Appendix 5

Addendum

SR 520
SR 520 BIKE PATH - BELLEVUE TO REDMOND

Addendum No. 1

| DESIGNED BY W. HICKEY | 3/99 | REGION NO. | STATE | FED. AID PROJ. NO. | ENVIRONMENTAL AND ENGINEERING SERVICE CENTER | Washington State Department of Transportation | SR 520 BIKE PATH - BELLEVUE TO REDMOND | PS3 |

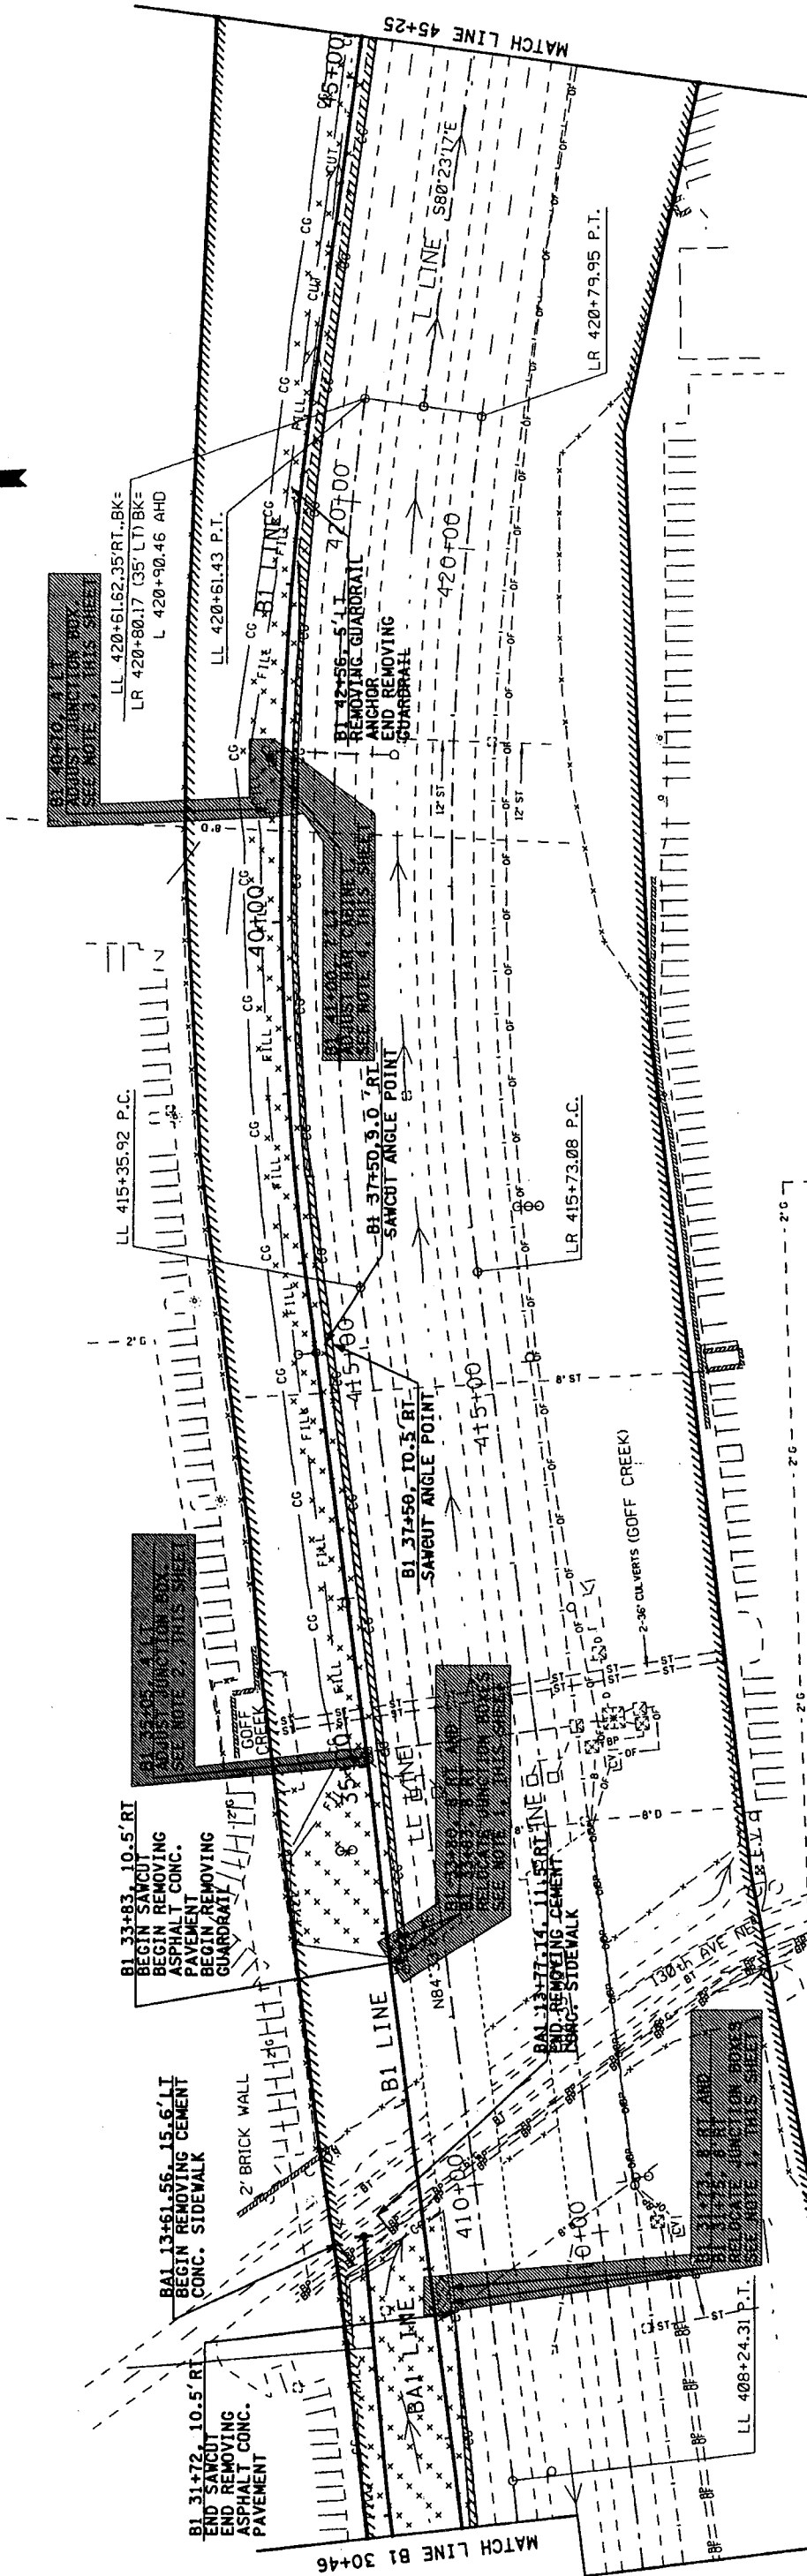
NOTES:
1. RELOCATE EXISTING JUNCTION BOXES TO SOUTH SIDE OF NEW BARRIER, ALONG SR 520 SHOULDER, AS DIRECTED BY ENGINEER. INSTALL NEW TRAFFIC BEARING MODIFIED JUNCTION BOXES, AS SHOWN ON SHEETS 01 AND 02, AND ADJUST TO GRADE.
2. REMOVE EXISTING JUNCTION BOX AND INSTALL NEW TRAFFIC BEARING MODIFIED JUNCTION BOX AS SHOWN ON SHEETS 01 AND 02, AND ADJUST TO GRADE.
3. REMOVE EXISTING JUNCTION BOX AND INSTALL NEW TRAFFIC BEARING MODIFIED JUNCTION BOX AS SHOWN ON SHEETS 01 AND 02, PULL BACK EXISTING 2'-6" AND 1'-6" TRP (TRINITY PAIR) CABLES, AND EXTEND CONDUIT. ADJUST JUNCTION BOX TO GRADE.
4. PULL BACK AND REINSTALL THE EXISTING 2'-6" AND 1'-6" TRP (TRINITY PAIR) CABLES IN THE EXISTING HAS (HIGHWAY ADVISORY RADIO) CABINET.

| REGIONAL ADM. J. OKAMOTO | | DATE | 5/29/01 | REVISED & ADDED NOTES | BY | | SITE PREPARATION/EXISTING UTILITIES | 104 OF 104 SHEETS |

Junction Boxes shall be relocated as shown in the Plans and as directed by the Engineer. Relocated Junction boxes shall be adjusted to finished grade.

Each Relocated Junction Box and Adjusted Junction Box shall have a new "Traffic Bearing Modified Junction Box" installed as shown in the Plans. The junction box lid shall be a galvanized diamond plate skid resistant and lockable lid.

TRAFFIC BEARING MODIFIED TYPE I JUNCTION BOX

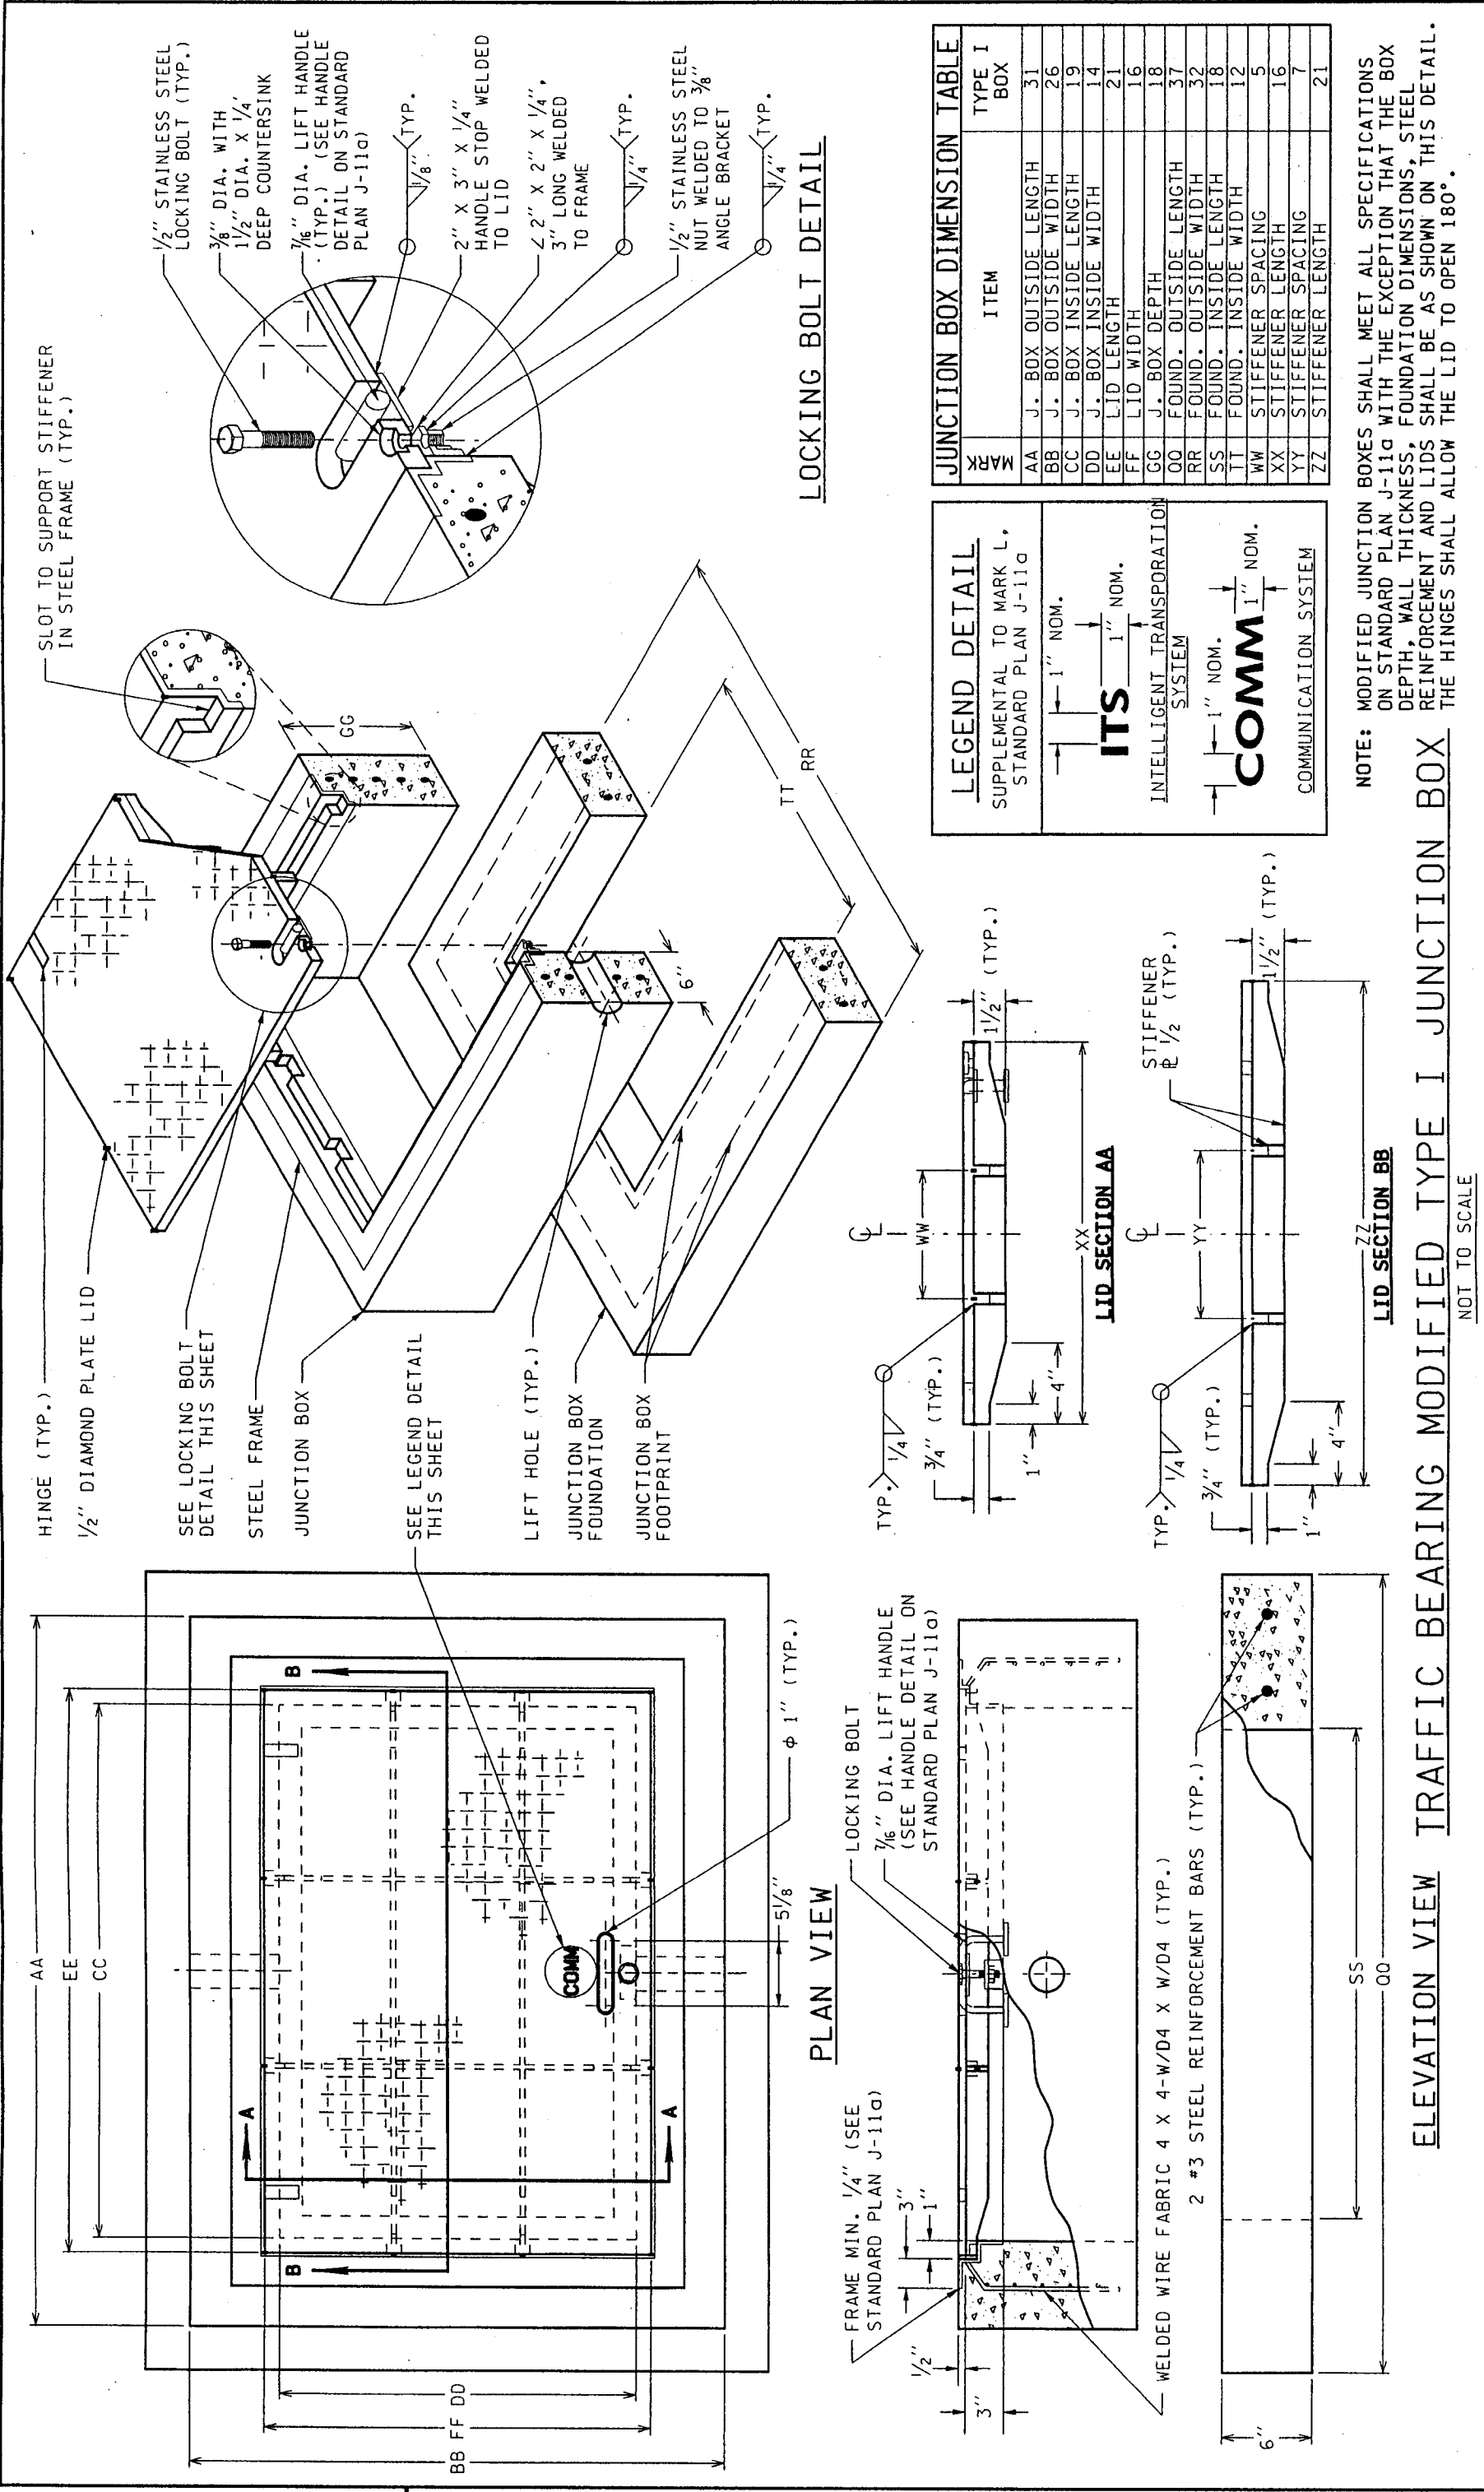
NOTE: MODIFIED JUNCTION BOXES SHALL MEET ALL SPECIFICATIONS ON STANDARD PLAN J-11a WITH THE EXCEPTION THAT THE BOX DEPTH, WALL THICKNESS, FOUNDATION DIMENSIONS, STEEL REINFORCEMENT AND LIDS SHALL BE AS SHOWN ON THIS DETAIL. THE HINGES SHALL ALLOW THE LID TO OPEN 180°.

79 OF 104 SHEETS

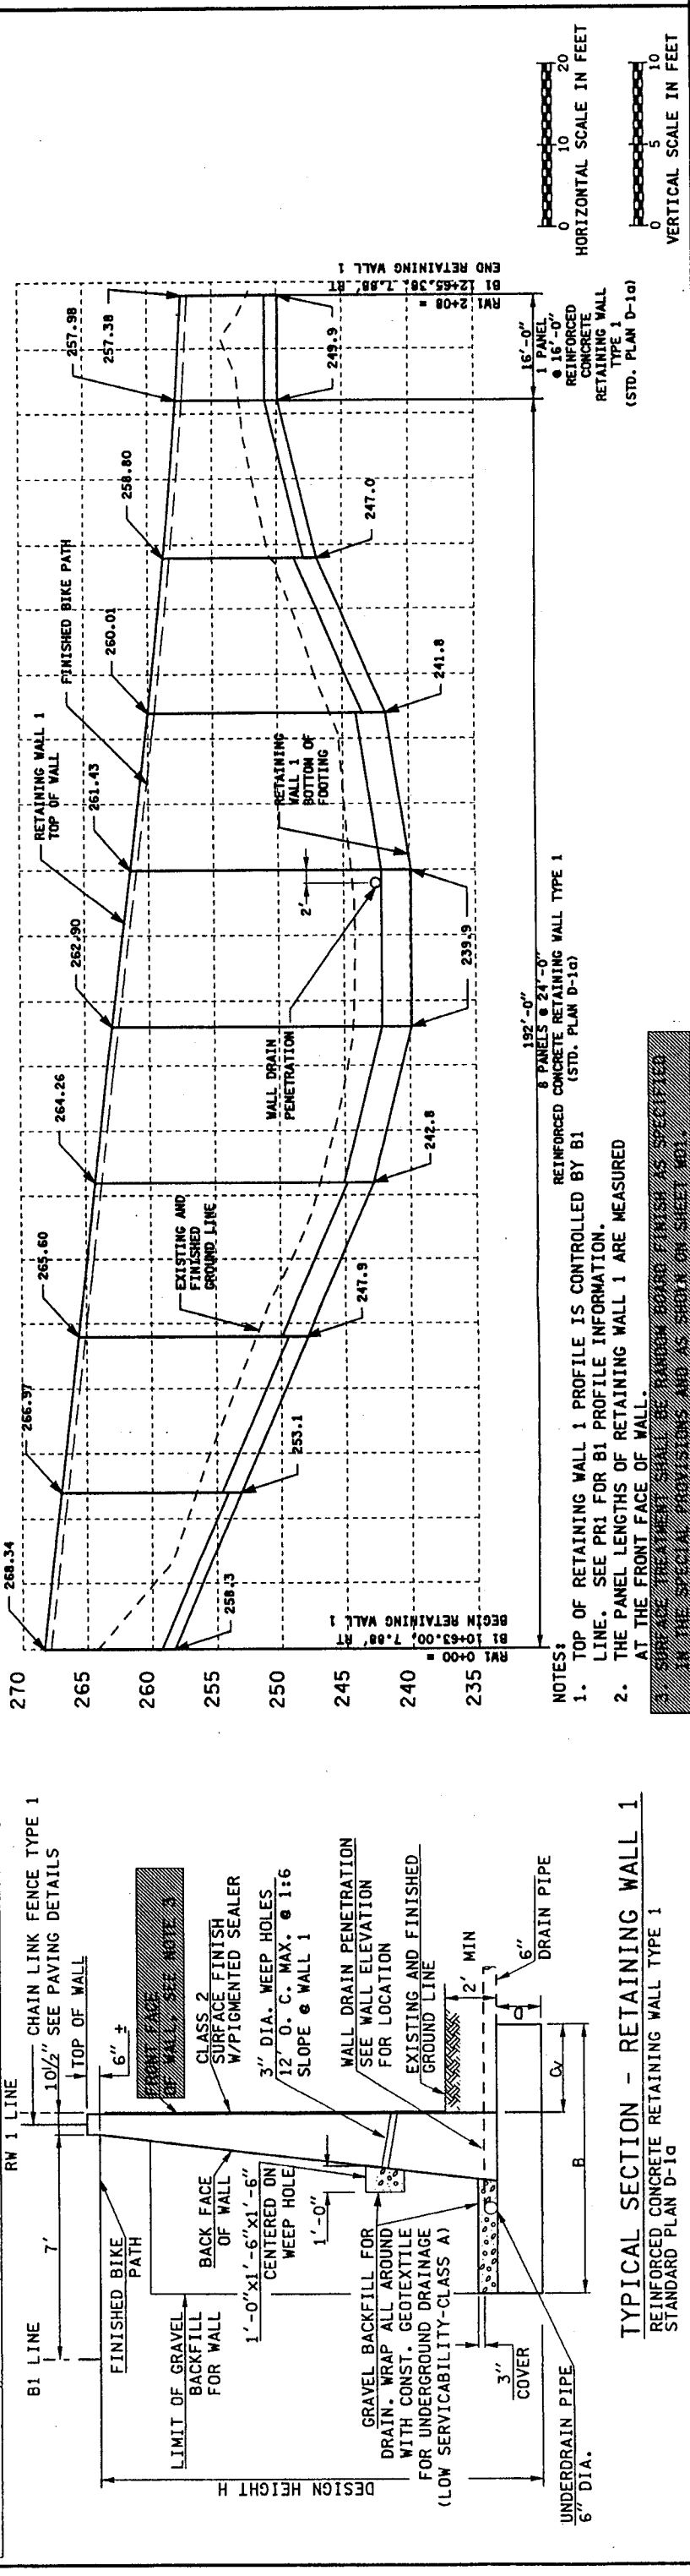
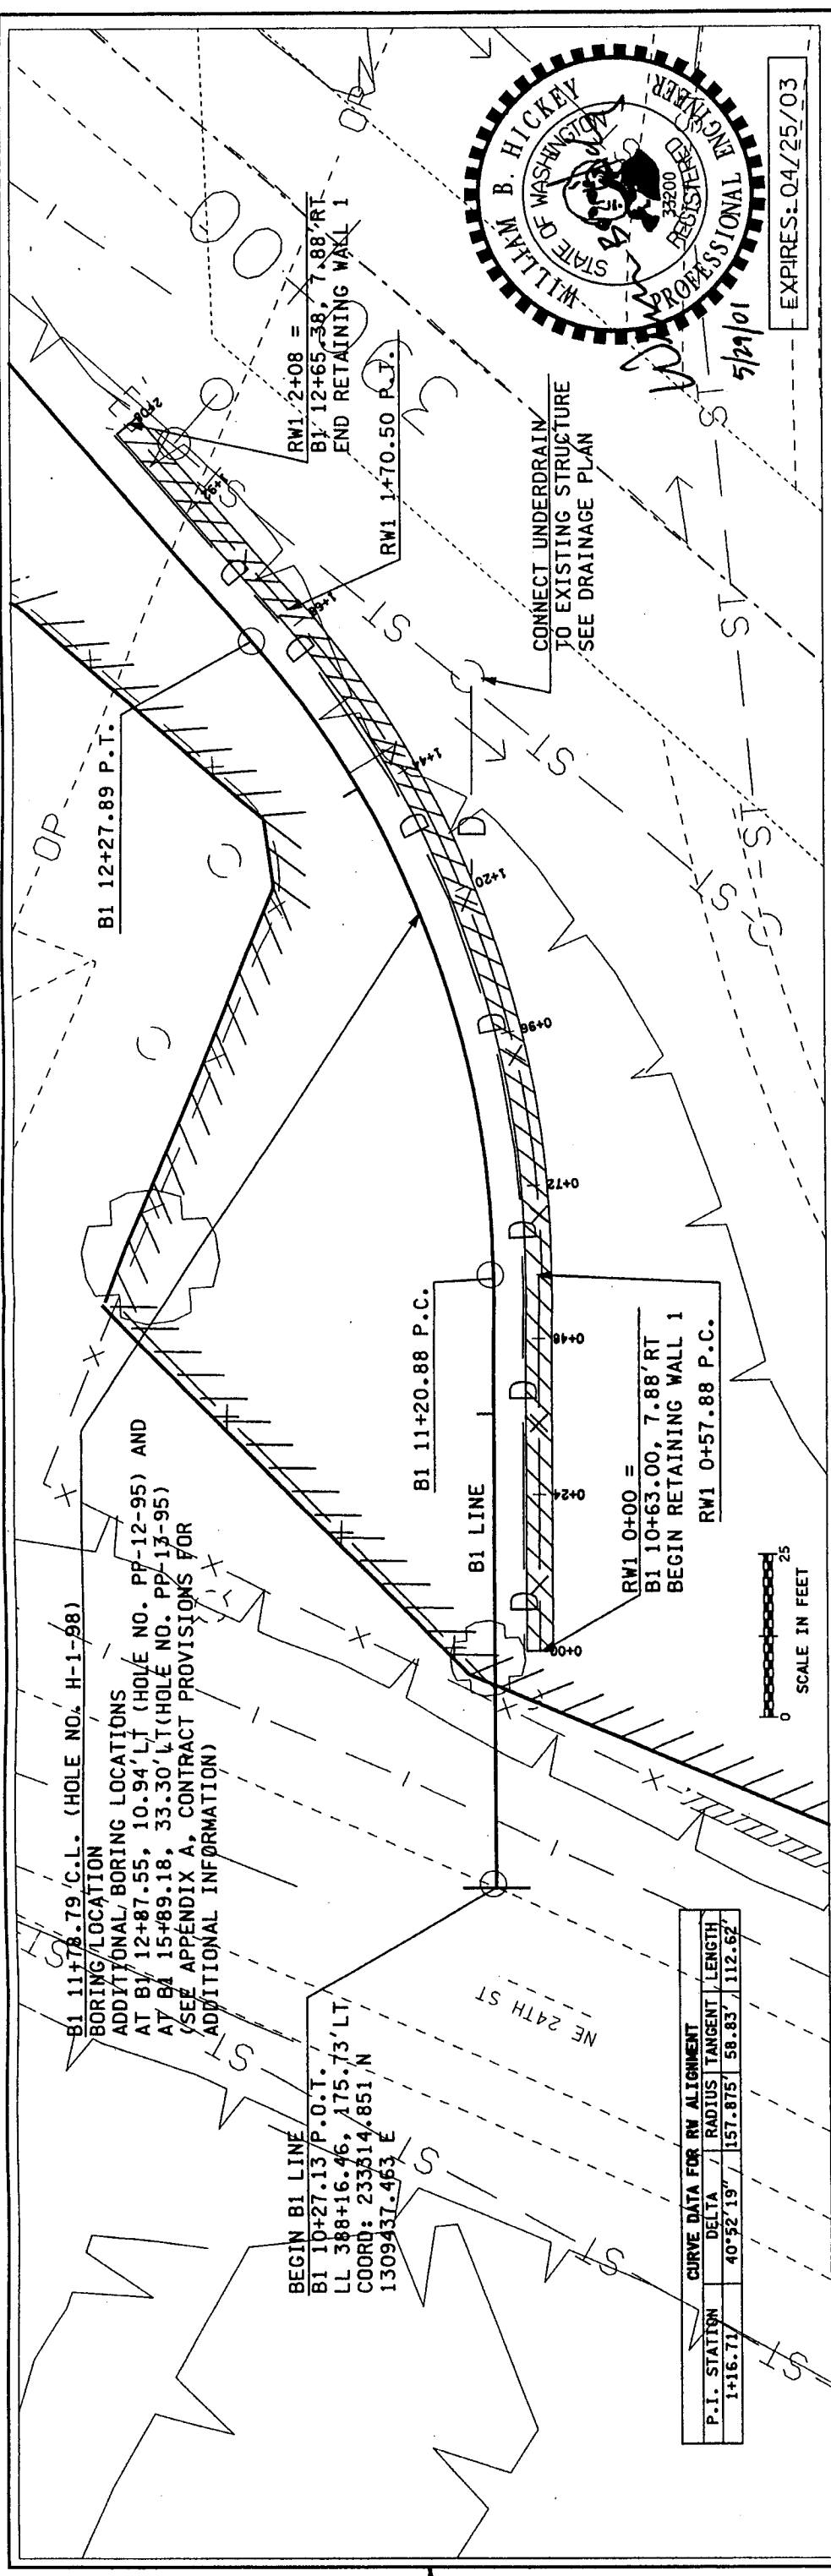
| ITEM | DESCRIPTION | QUANTITY | UNIT | AMOUNT |
|--|--------------------------|----------|-------|--------|
| <p>NOTE: CONCRETE FASCIA PANELS SHALL BE RANDOM BOARD FINISH. AS SPECIFIED IN THE SPECIAL PROVISIONS AND AS SHOWN ON SHEET NO. 1.</p> | | | | |
